Access Compliance Report

Public Rights-of-Way

Intersection ID: 51032	Main Street: SUMNER_HALL_LN	Cross Street: OLD_PROVIDENCE_RD	Location: NW
ADA ID: 00E69DE96963	Ramp Type: PerpDiag	Initial Pass/Fail: Fail	Overall Compliance: No
		Severity Score: 37.5

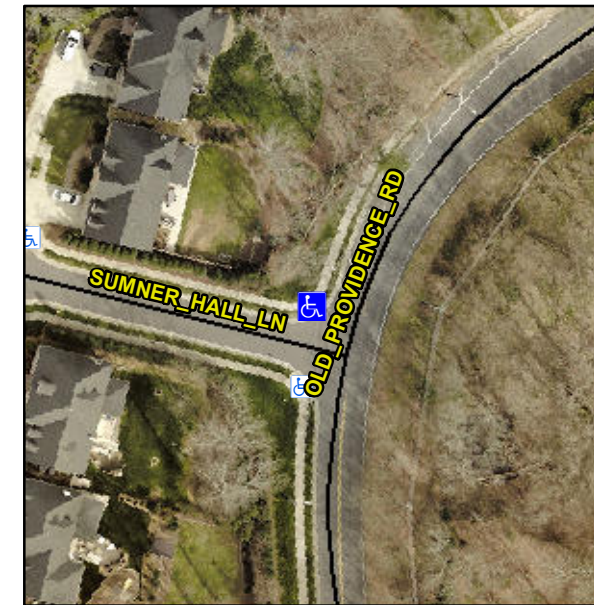
Not Found, R304.2.2, R304.5.3

Compliance	Description	Data	Compliance	Description	Data
N/A	Ramp Length (in)	94.5	No	Ramp Slope (%)	10.1
Yes	Ramp Width (in)	48.0	No	Ramp XSlope (%)	7.5
N/A	Flare Type LT	N/A	N/A	Flare Type RT	N/A
N/A	Flare Slope LT (%)	N/A	N/A	Flare Slope RT (%)	N/A
N/A	Flare Traversable LT?	N/A	N/A	Flare Traversable RT?	N/A
N/A	Landing Length (in)	N/A	N/A	DWS Provided?	N/A
N/A	Landing Width (in)	N/A	N/A	DWS Contrast?	N/A
N/A	Landing Slope (%)	N/A	N/A	DWS Length (in)	N/A
N/A	Landing X Slope (%)	N/A	N/A	DWS Full Width?	N/A
N/A	Landing Curb? (Y/N)	N/A	N/A	DWS Offset (in)	N/A
N/A	Shared Landing?	N/A			
N/A	Gutter Ponding?	N/A	N/A	Gutter Slope (%)	N/A
N/A	Gutter Lip Ht (in)	N/A	N/A	Gutter X Slope (%)	N/A
N/A	Painted X Walk1?	No	N/A	Painted X Walk2?	No
	X Walk 1 Direction	To SW		X Walk 2 Direction	To E
N/A	X Walk 1 Width (in)	N/A	N/A	X Walk 2 Width (in)	N/A
	X Walk 1 Slope (%)	3.7		X Walk 2 Slope (%)	2.7
	X Walk 1 X Slope (%)	3.5		X Walk 2 X Slope (%)	6.6

Remove & Replace Curb Ramp With Two New Directional Ramps or Equivalent.
